McKinley High School – Construction Documents
800 E McKinley St, Baton Rouge, LA 70802
Domain Chasm Project No. C24-0038/24009

ADDENDUM NO. 2

A8.703

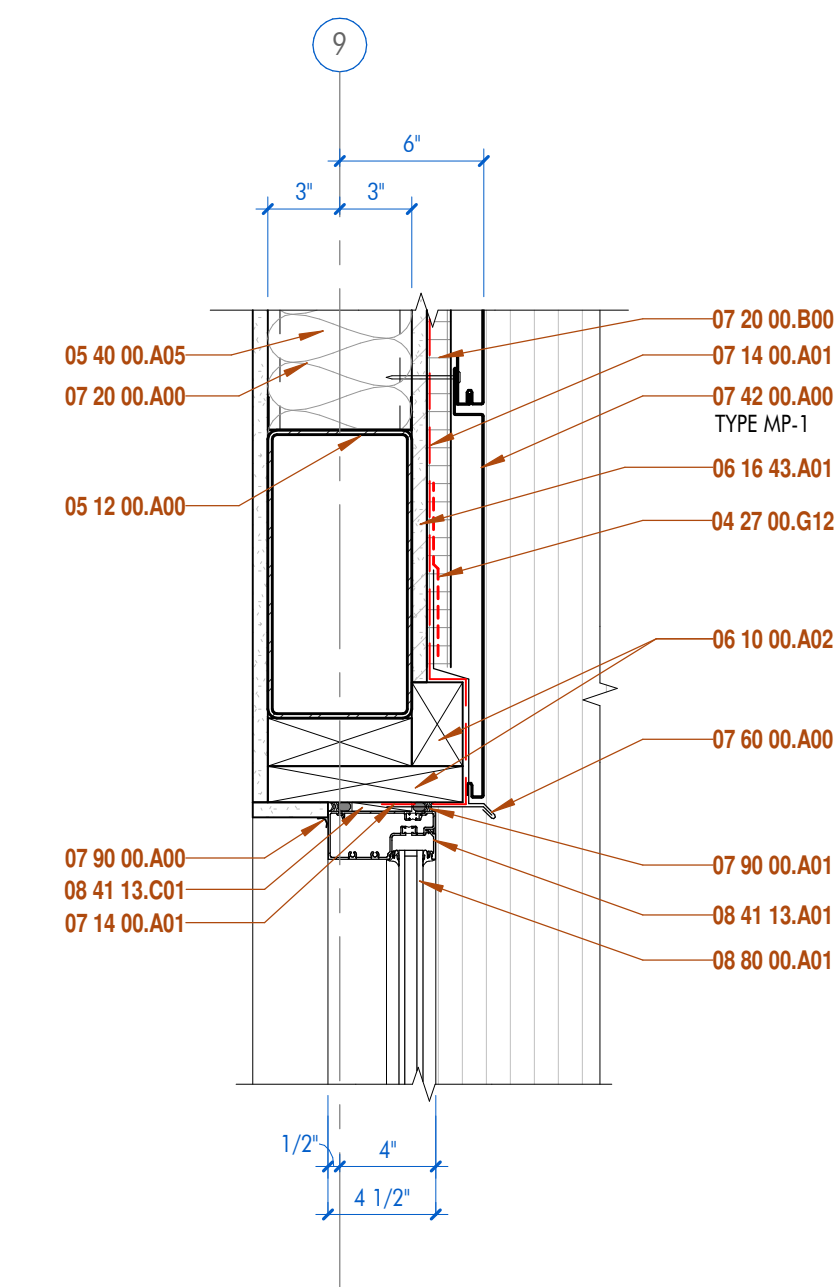
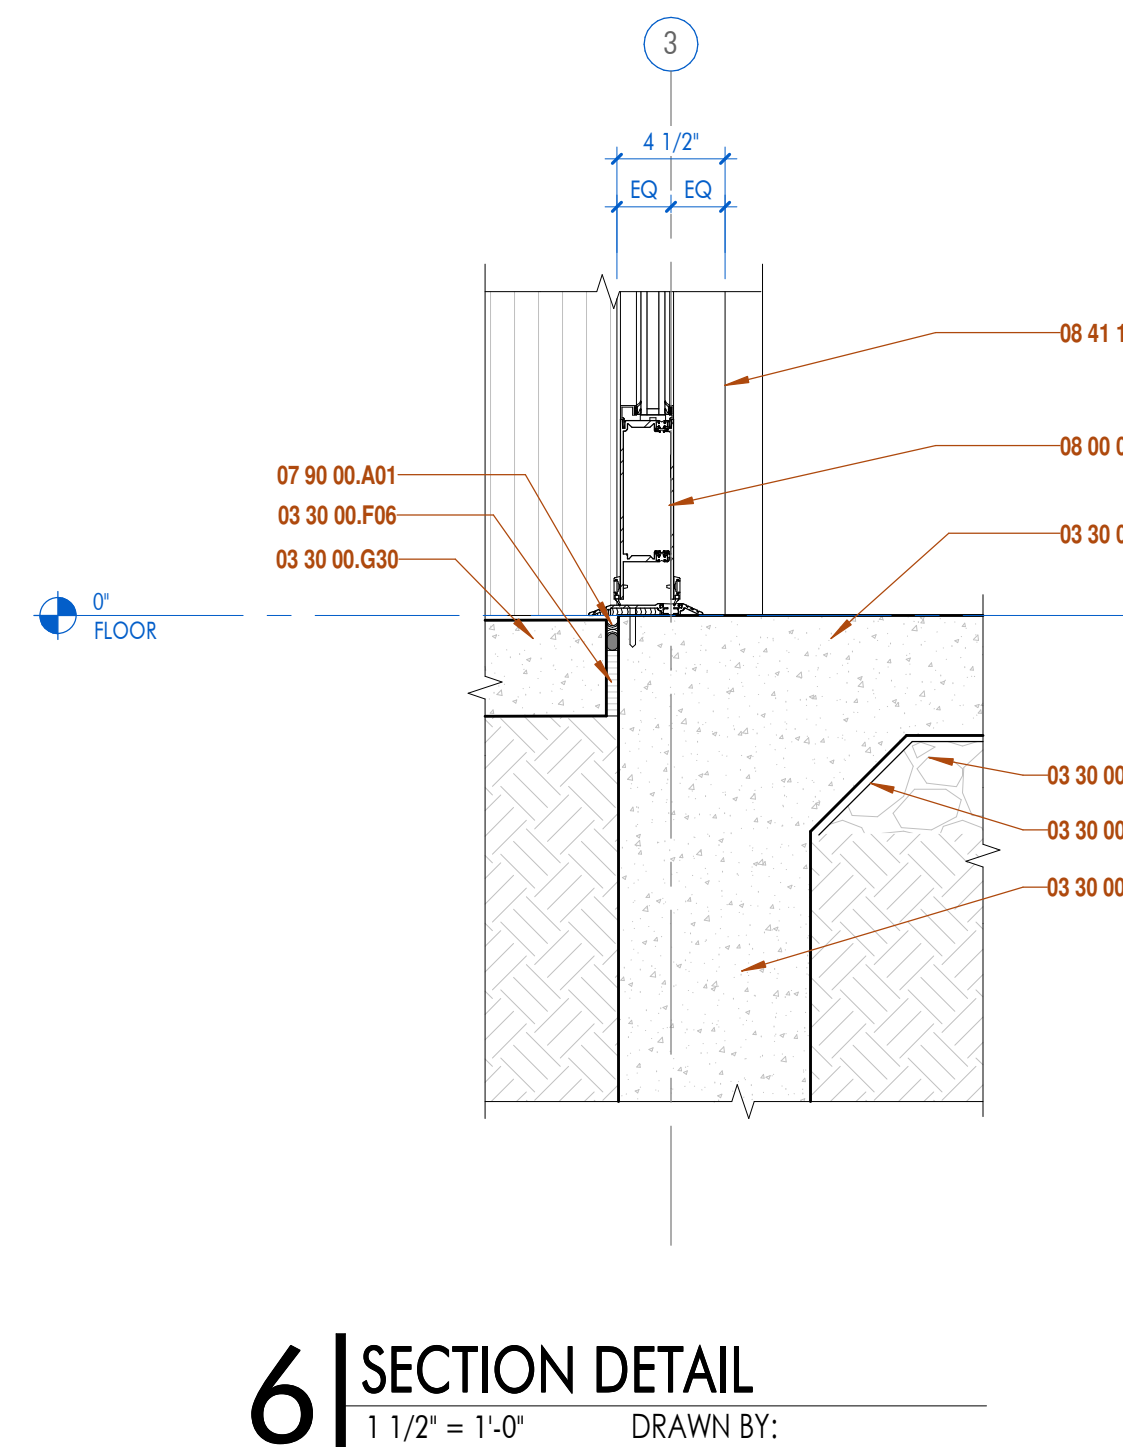
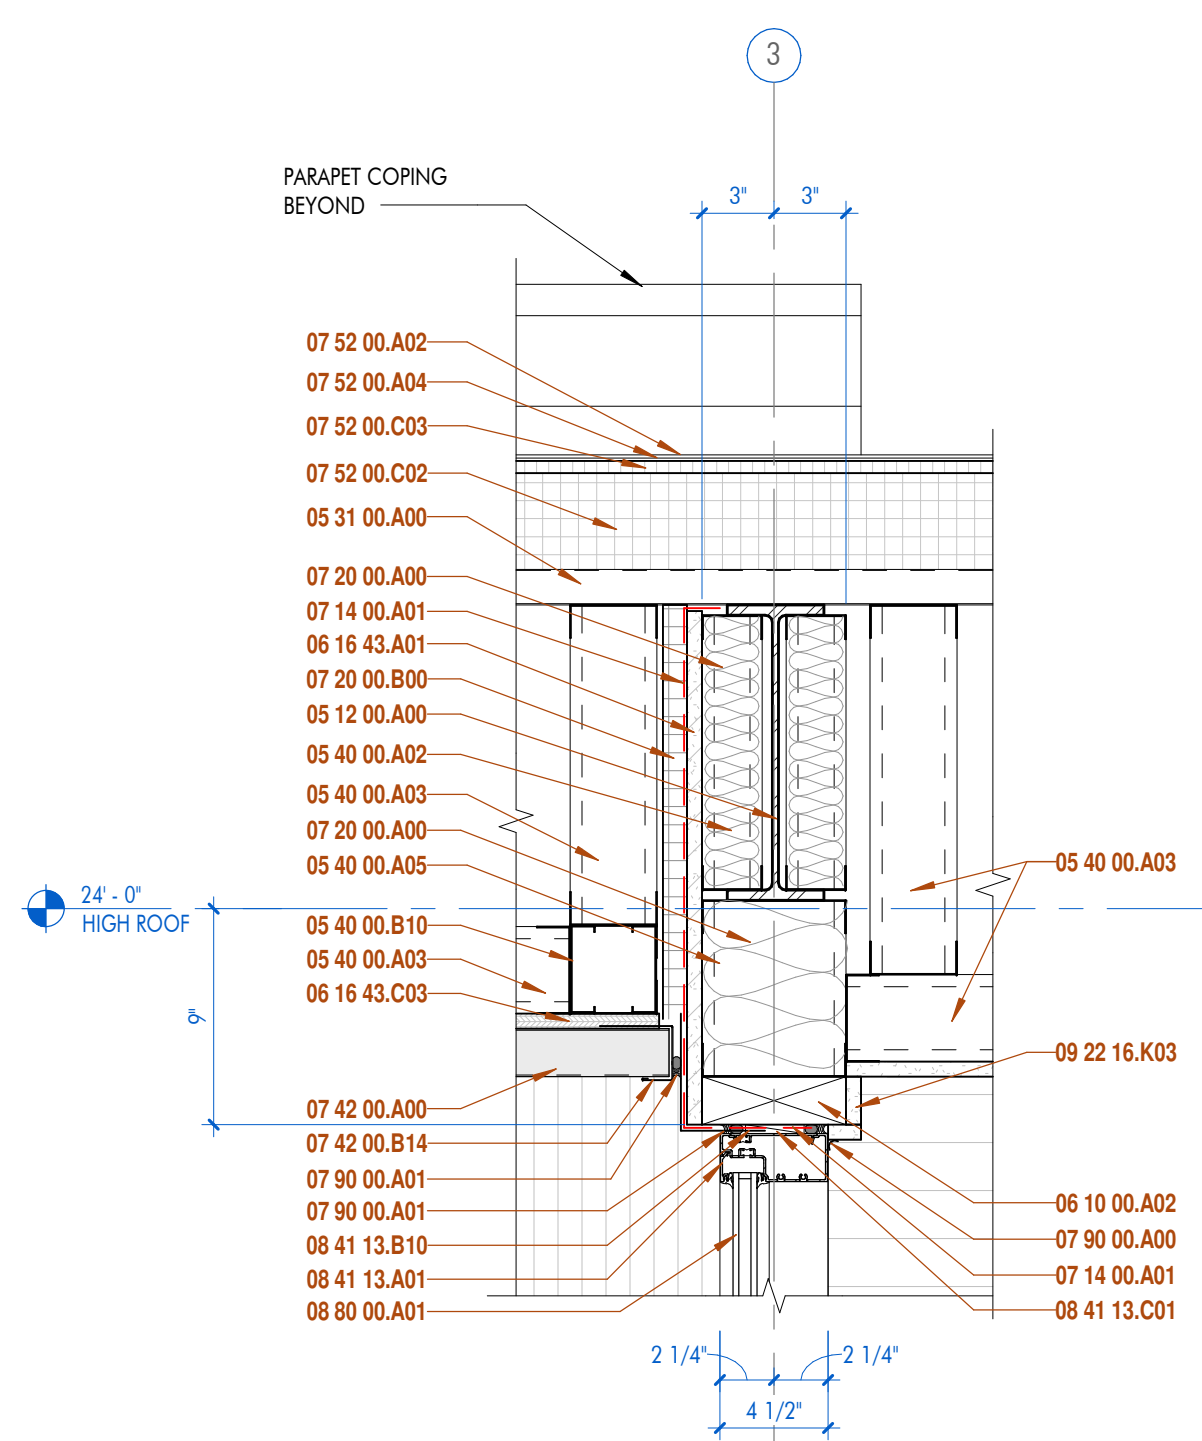
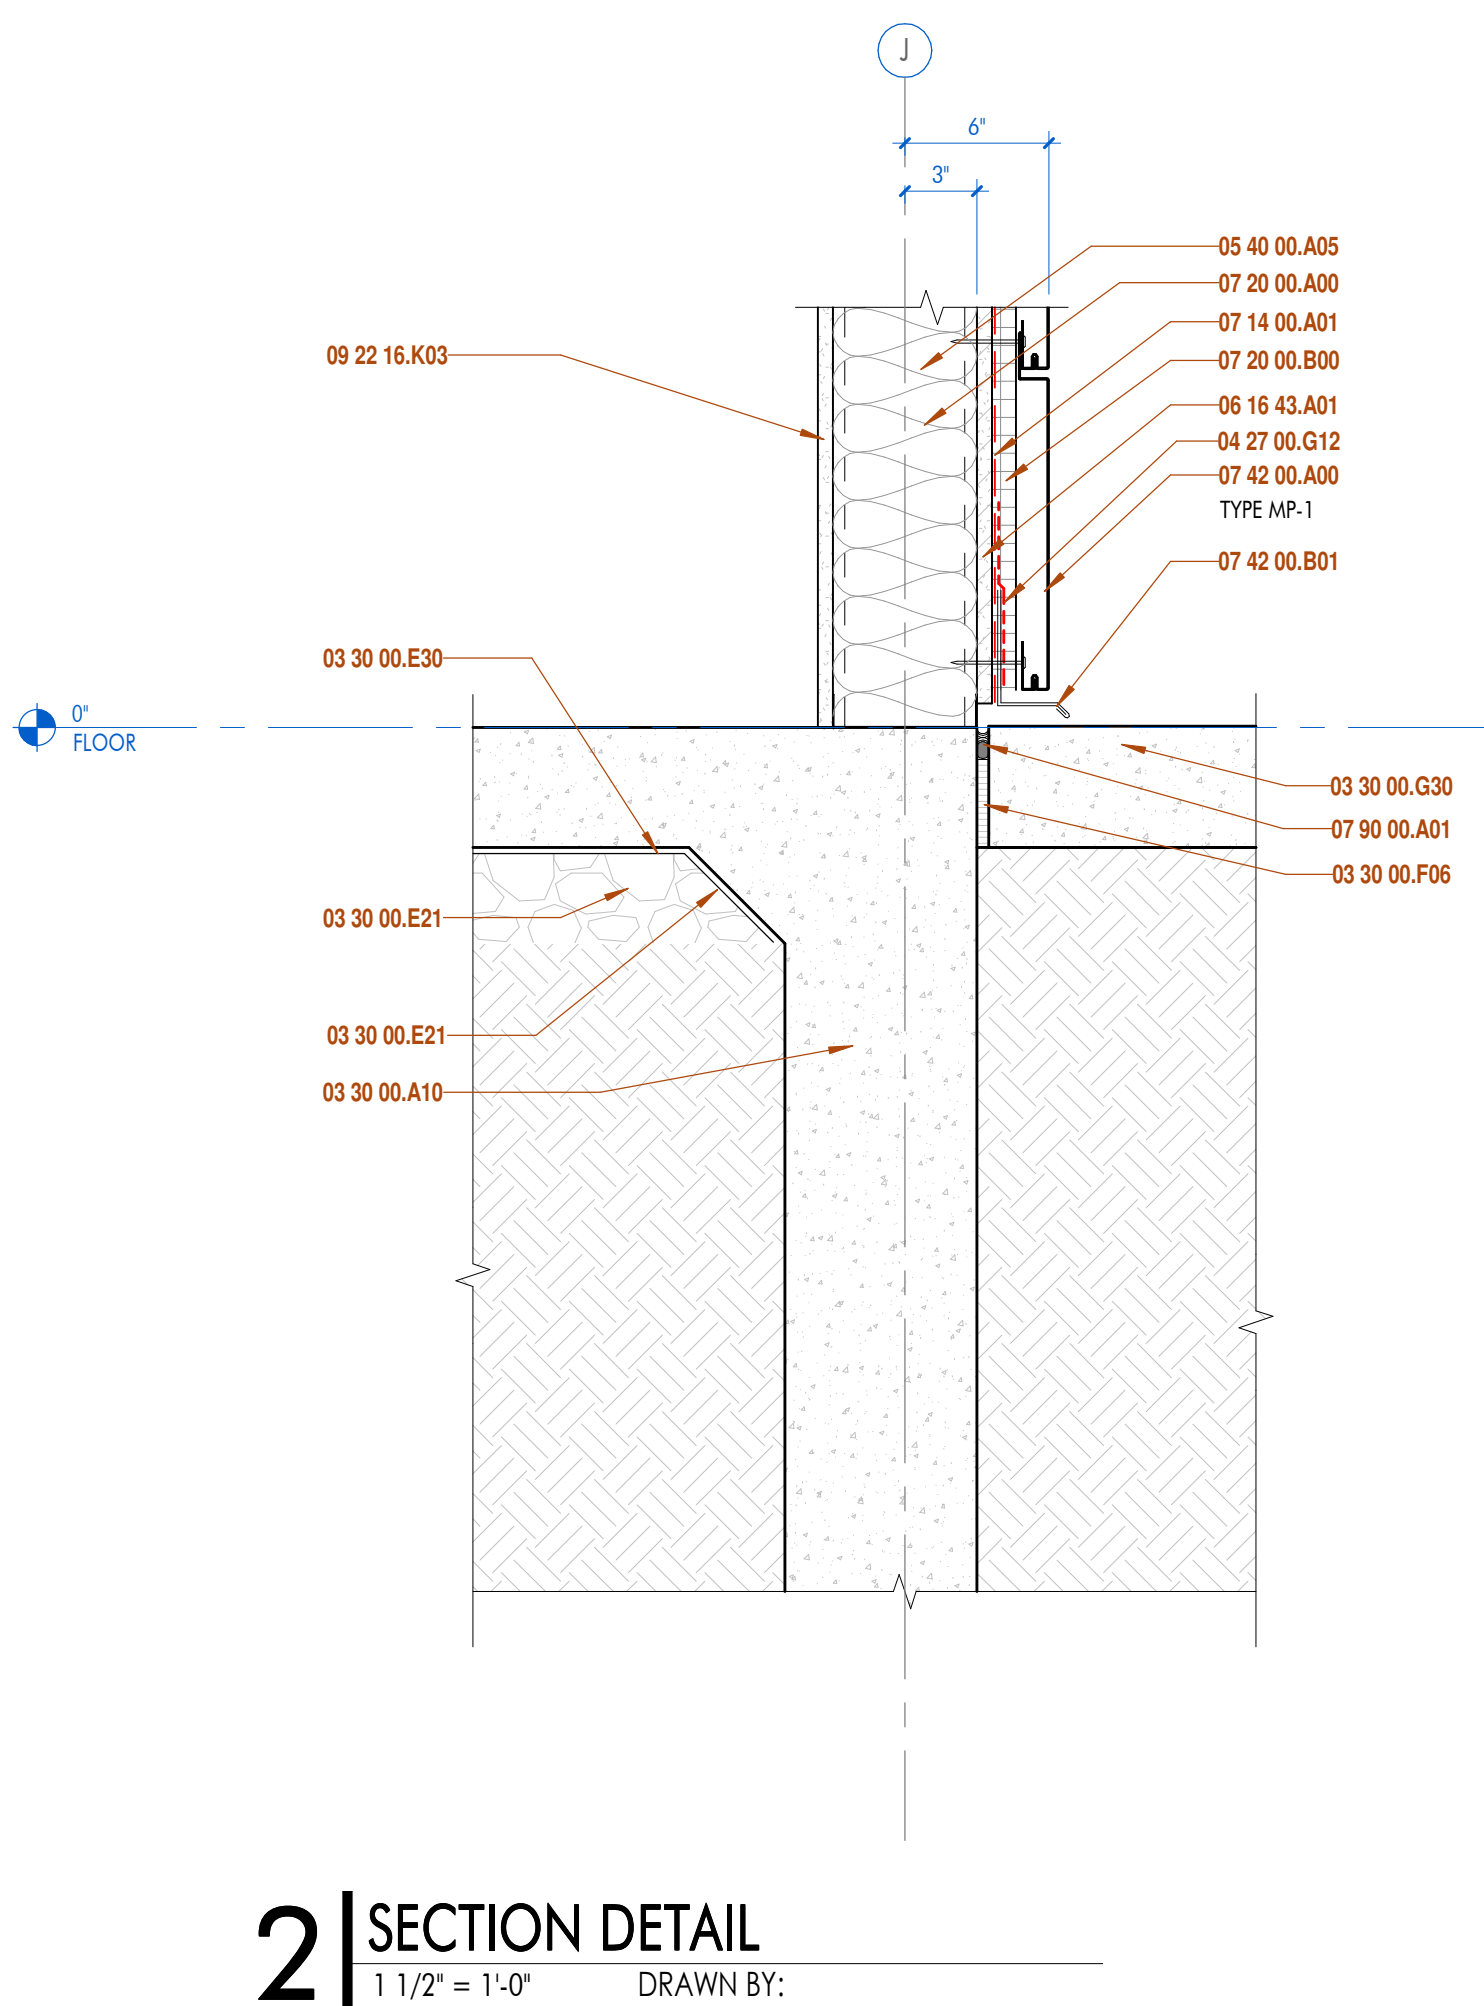
13. Sheet A8. 703 – Wall Sections – New Arts Bldg. - Remove previously issued sheet and replace sheet with revised attached sheet.
 - a. Detail 1/A8.703 Wall Sections – Removed tube steel cross bracing from wall.

14. Sheet A8.703 – Wall Sections – New Arts Bldg. - Remove previously issued sheet and replace sheet with revised attached sheet.
 - a. Detail 2/A8.703 Wall Section – Revised wall section.
